Radio DDIN Installation with Rear Camera

Classification: Parts Bulletin **Section/Group:** 17 - Electrical **Country/Region:** Global

Year: 2008-2009 **Model:** Roadster **Version:** 1.5 / 2.0

This Service Bulletin supersedes SB-12-17-005 dated 22-Oct-12. The content changes are identified with double vertical lines and italics. Changes include the installation of a zener diode in series with the rear camera input wire. Please discard the previous Service Bulletin and replace with this Revision 2.

Figure 16

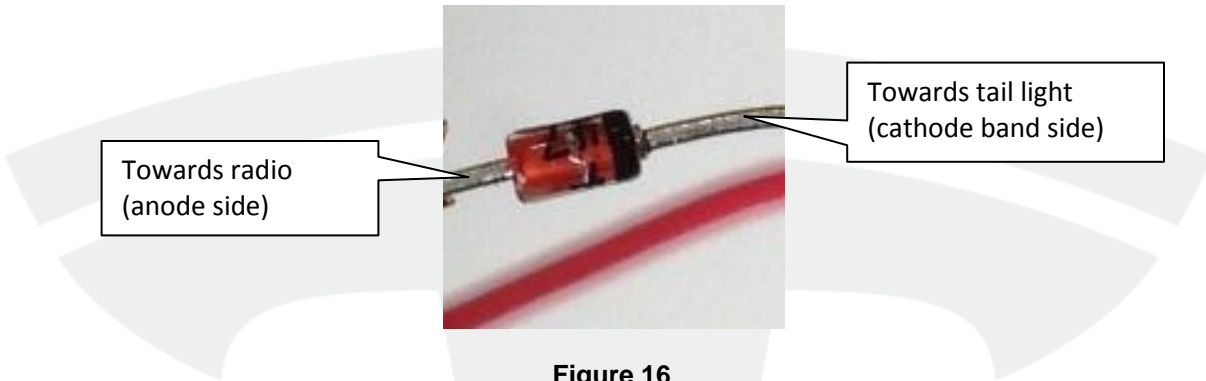
NOTE: If a rear camera is to be installed, go to Step 1 in the Installation of the Rear Camera section. The rear camera reverse input wire will require a zener diode to be installed for proper operation. This diode will be installed in back of the radio assembly before dash reassembly.

1. Install a 1N4732, 4.7 volt-1 Watt zener regulator diode in series into the input wire behind the radio assembly. The zener diode is directional. For the rear camera visual display to properly operate, the anode side is placed in line towards the radio unit and the cathode side of the diode is spliced towards the tail light (Figure 16).
